APPLICATION NO.	FILING DATE	FIRST NAMED INVENTOR	ATTORNEY DOCKET NO.	CONFIRMATION NO.
10/604,729	08/13/2003	Xiaokai NIU	4025	1728

Office Action Summary

DETAILED ACTION

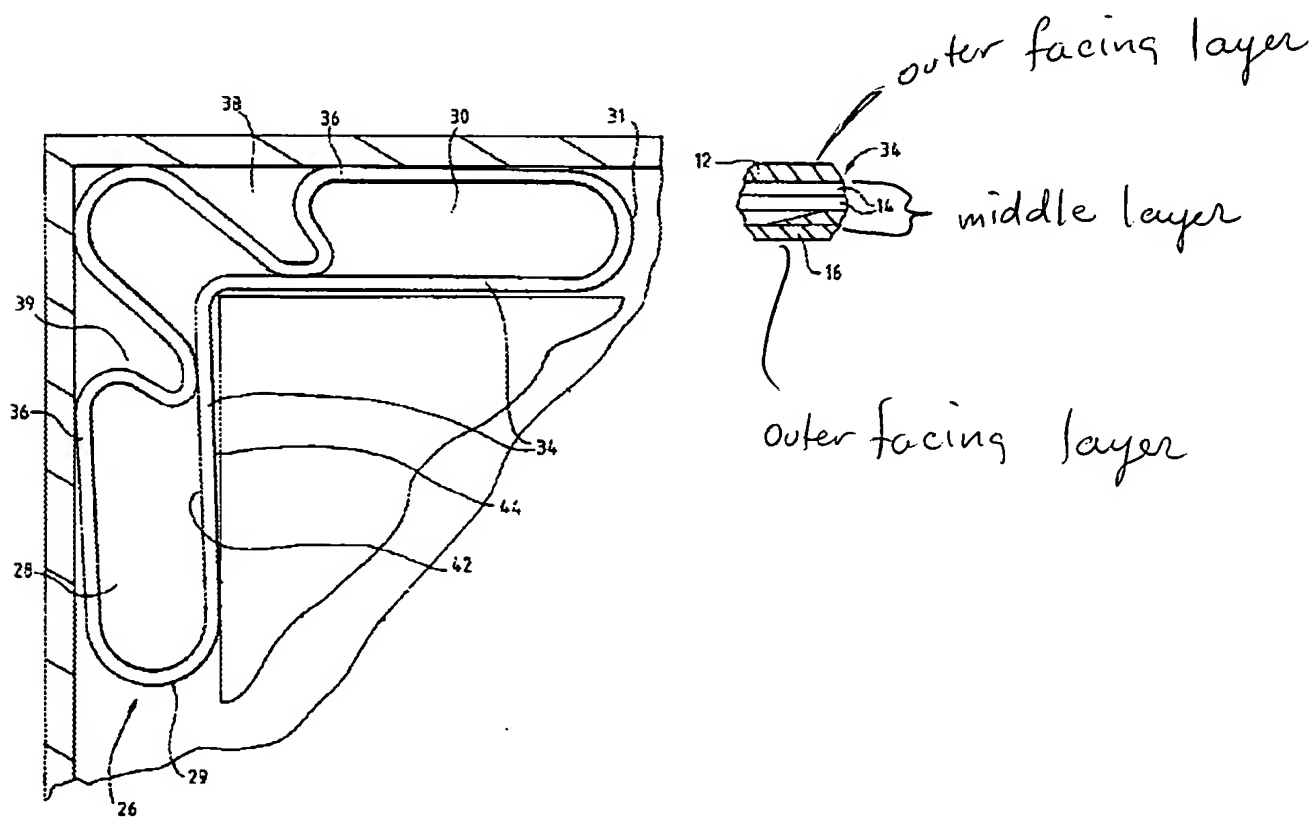
Claim 1 is rejected under 35 U.S.C. 102(b) as being anticipated by Qiu (6,186,329). Qiu teaches each feature of the claimed invention as shown below.

Claims 2-7, 10, 11 and 16-20 are rejected under 35 U.S.C. 103(a) as being unpatentable over Qiu (6,186,329), in view of Braun (5,799,797). Qiu teaches, substantially, each feature of the claimed invention as discussed above. Qiu does not teach an embossed middle layer or an I-beam or circular cross-sectional structure. Braun teaches an embossed middle layer (See Braun's Figure 3 below). It would have been obvious to one of ordinary skill in the art at the time of invention to have modified Qiu's base sheet to have Braun's cross-sectional structure in order to construct a lighter stronger support. Regarding claim 3, Braun clearly teaches a dimpled middle layer. Regarding claim 4, Braun's middle layer clearly teaches embossing on one side of each of the outer layers. Regarding claims 17 and 19, it would have been obvious to one of ordinary skill in the art at the time of invention to have formed Qiu's structural member into any of a number of well known cross sectional designs in order to support external cushioning loads most efficiently.

FIG. 3

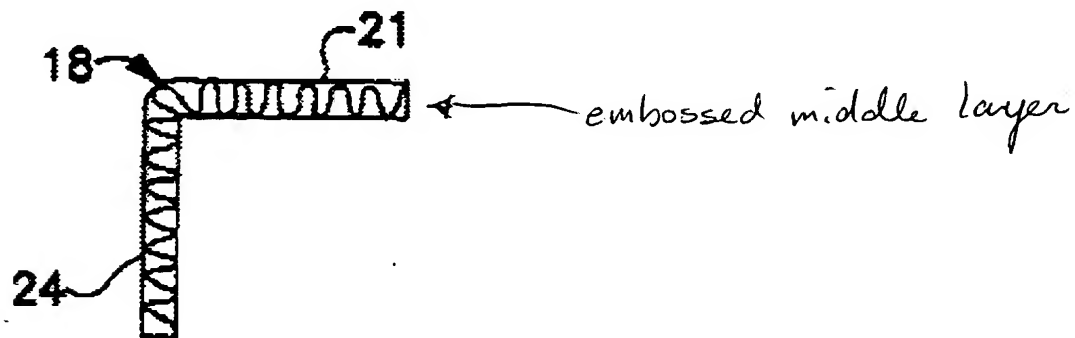
The drawings are objected to under 37 CFR 1.83(a). The drawings must show every feature of the invention specified in the claims. Therefore, the I-shaped and round cross-sections of claims 17 and 19 must be shown or the feature(s) canceled from the claim(s). No new matter should be entered.

Claims 4 and 17 and 19 are rejected under 35 U.S.C. 112, second paragraph, as being indefinite for failing to particularly point out and distinctly claim the subject matter which applicant regards as the invention. Claim 4 recites paper embossed "on one side only". It is unclear how the paper is embossed on one side only. When a depression is made on one side a corresponding bump is made on the other. In other words, the specification teaches both sides being necessarily affected by embossing and the drawings (Figure 3) show embossing effect on both sides.
